Proposal Request

*Rifle Fire Protection District
Fire Station #3
416 Last Chance Drive
Rifle, CO 81650*

Proposal Request Number: *16*

Rifle Fire Protection District 2805-01
 Fire Station #3
 xxxx Last Chance Drive
 Rifle, Colorado 81650
 FILE: 280501S4.1 DATED 10-22-09

REVISION APPLIES TO DETAIL 4/S43 HOLD DOWN SCHEDULE

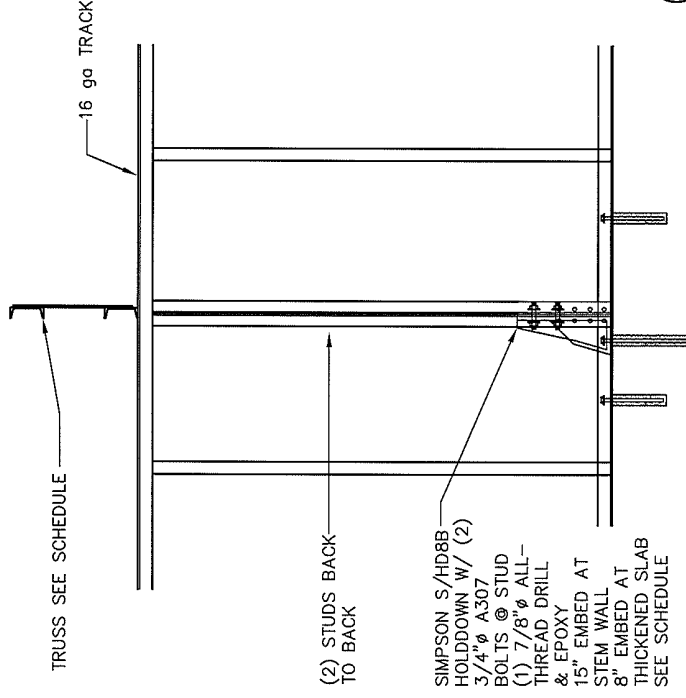
Please find attached revision showing requirements for double studs and holdowns @ selected steel trusses. These satisfy load requirements as defined by the truss manufacturer's final design.

HOLD DOWN SCHEDULE		
TRUSS No.	GRID LINE	HOLD DOWN REQUIRED
G01	(E2)	YES
G02	(E8)	YES
G05	(B)	NO
G07	(A)	YES
G08	(B)	YES
T12	(C)	YES
T15	(B) (A)	YES
T16	(B) (A)	YES
T30	(E2)	YES
T17	(B) (A)	YES
T58	(C)	NO
T59	(C)	NO
T33	(B)	YES
